**Subject:** Concerns from 20 Hawman Ave re Z.18.013 and OP.18.008 for First Avenue Properties  
**Attachments:** Traffic Concern - 20 Hawman Ave.jpg; SUB1\_April-9-2018\_A201\_Parking Levels\_8.5x14\_5225 Highway 7.pdf; SUB1\_April-9-2018\_Report\_Arborist\_5225 Highway 7.pdf; SUB1\_April-9-2018\_Report\_FSR & SWM\_5225 Highway 7.pdf

**PUBLIC HEARING  
COMMUNICATION**

I am writing to document and express some concerns that I have regarding the submitted development proposal along Highway 7 / Kipling Ave / Hawman Ave by First Avenue Properties, KFA Architects & Planners and HUMPHRIES Planning Group Inc. (Z.18.013 and OP.18.008)

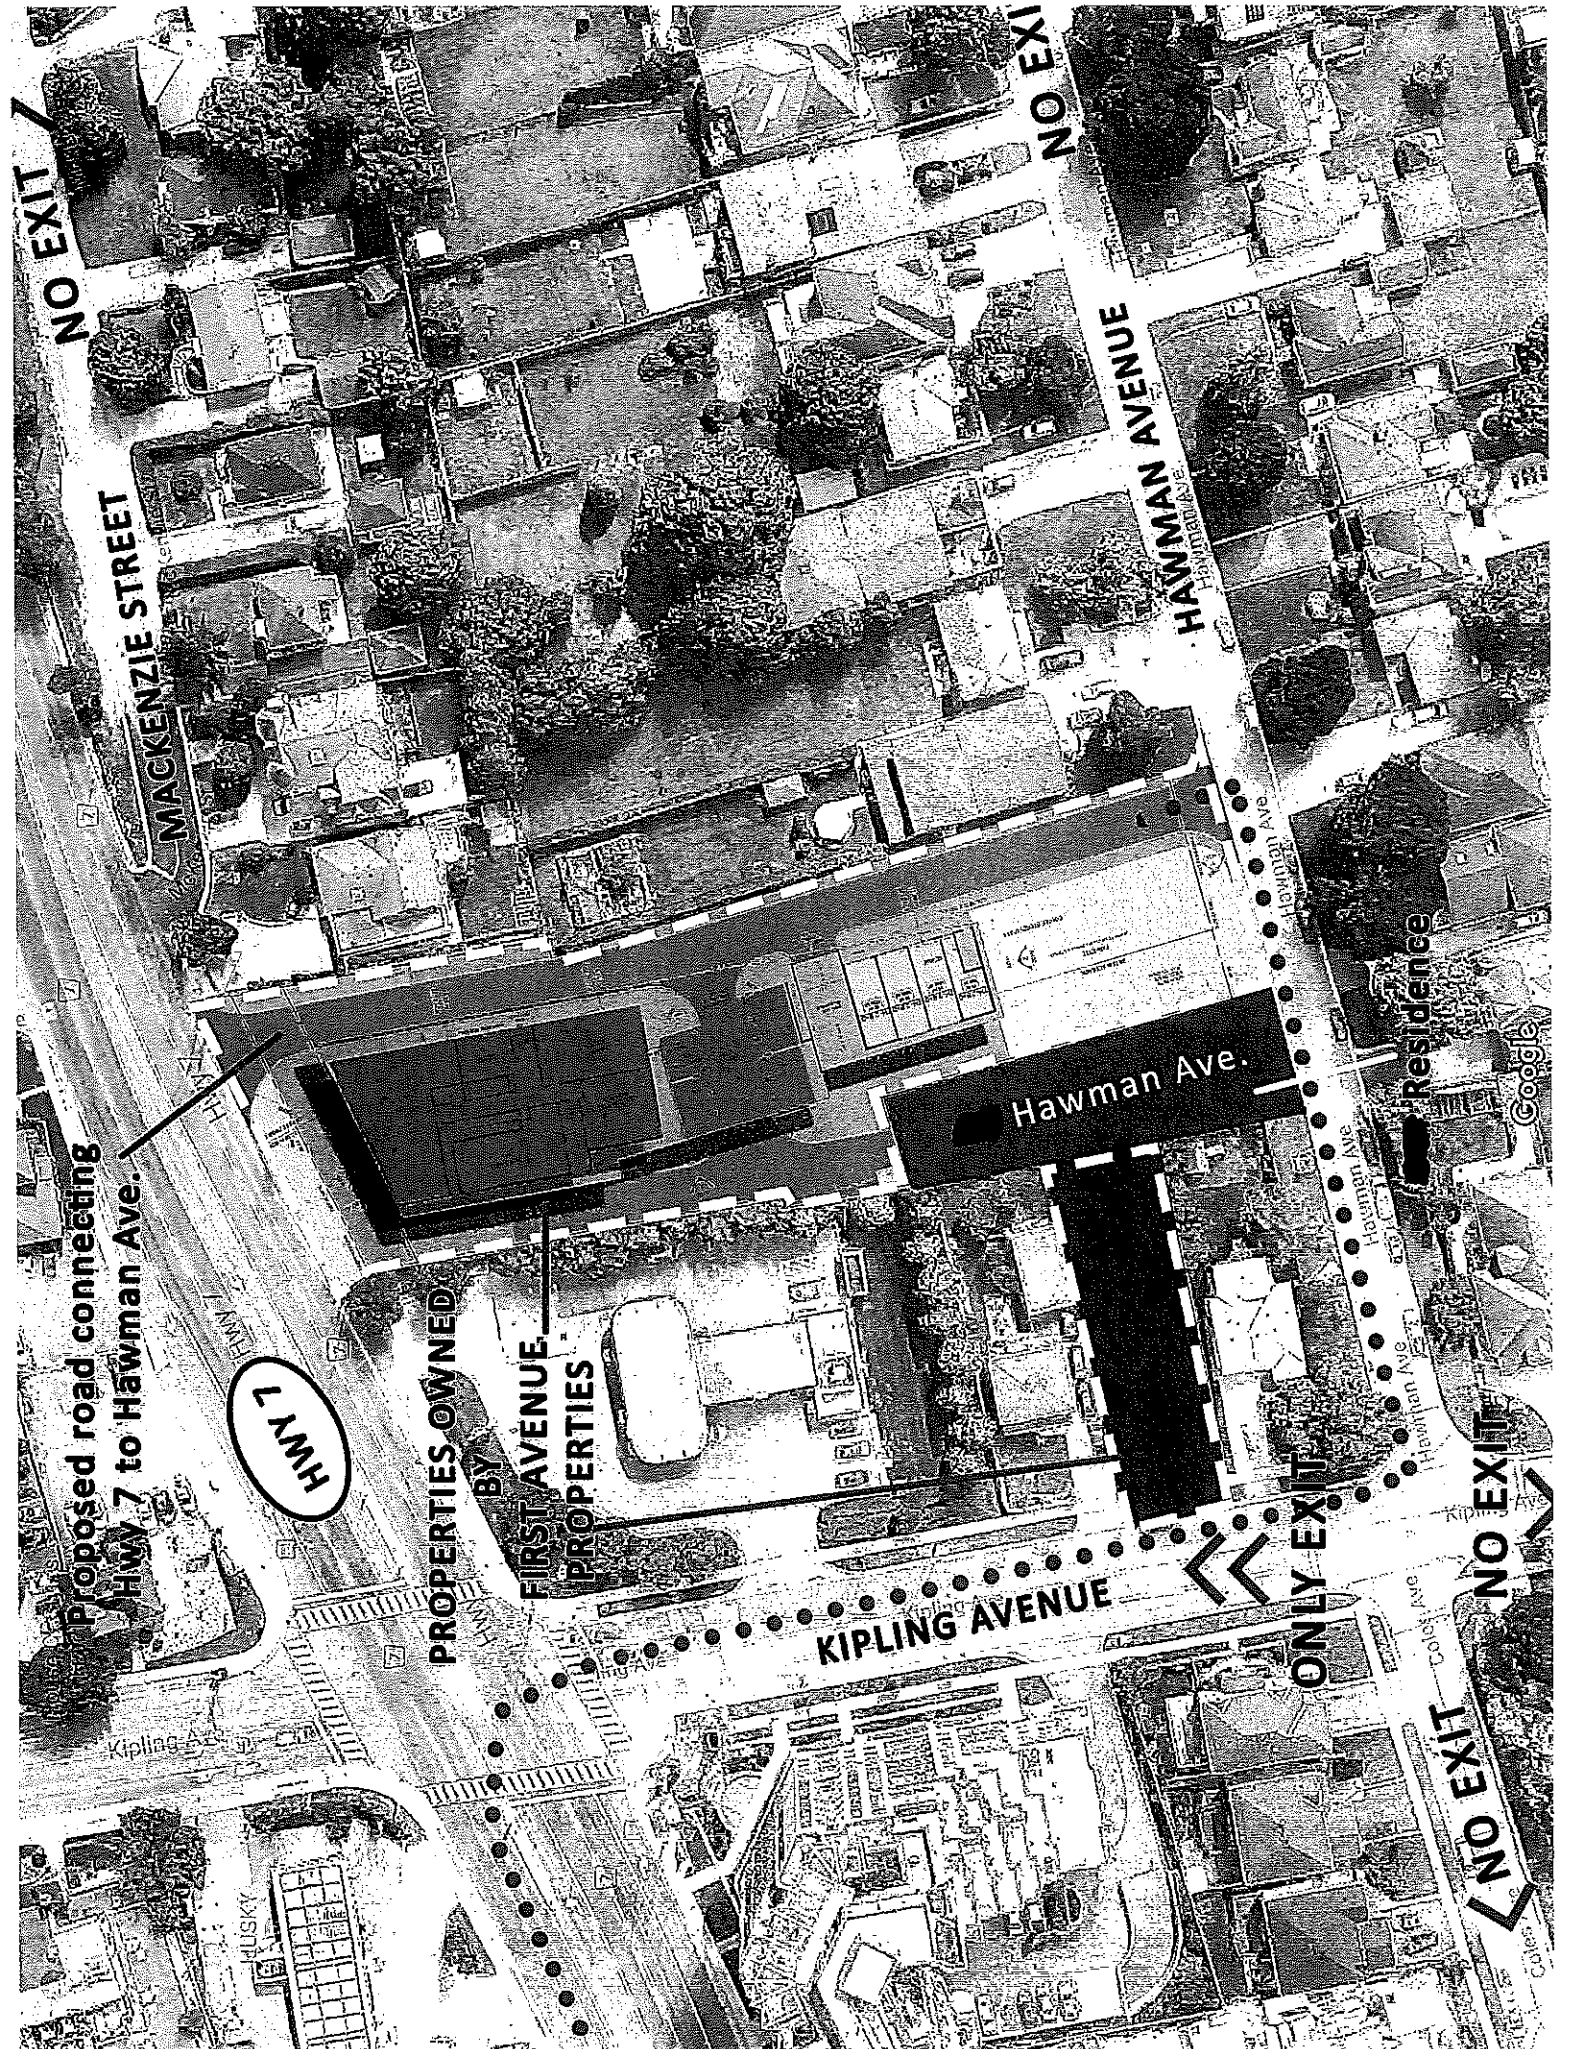
Another big concern is the proposed road/access point that this development wants to create that will stretch from Hwy 7, southbound to Hawman Ave. Currently Hawman Ave is a residential street with no exit, utilized by the local residents only. The only purpose this access road will serve is to allow traffic to flow in/out of the proposed site to travel west on Hawman Ave, then North on Kipling (no southbound exit on Kipling) and then West on Hwy 7. My main concern is that my house and driveway is the only house on Hawman Ave between the proposed road access point and Kipling Ave. I will quite literally be boxed in every morning and evening during rush hour when vehicles will be travelling on Hawman Ave. Not to mention the impact that this additional traffic will have on the residents of Hawman Ave. There is no other exit on Hawman Ave and this proposal concerns me, especially considering that my house in particular is the only one uniquely affected by vehicles that will be lined up in front of my driveway trying to make a right hand turn on to Kipling. Please see the attached jpg file titled "Traffic Concern - [REDACTED] Hawman Ave" that I have prepared which illustrates this concern. Also how will this increase of traffic from this proposed road affect school buses? Currently busses come

along Hawman Ave for pick up and drop off locations. Will this affect mail delivery? Mail trucks use Hawman Ave when delivering mail. Will this affect garbage trucks, recycling trucks and fire truck / ambulance access should they be needed?
